WMATA SAFE Field Oversight Report

Contract: CRB0020_07 – Dulles Phase 2 WMATA Oversight – Package B

Activities' Date: Tuesday, April 27, 2021 (Choose date from drop down)

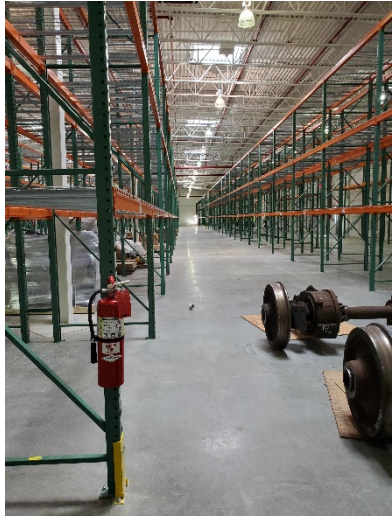
<p>1</p> 	<p>2</p> 	<p>3</p> 
Activity 1 – 1. Missing bollards in front of the downspouts. Bare grounding wire under levelers.	Activity 1 – 2. Rollup door manual pull chain – chain holder	Activity 1 – 3. Photo showing conflict with adjacent electrical equipment and missing bollards to protect electrical equipment
<p>4</p> 	<p>5</p> 	<p>6</p>
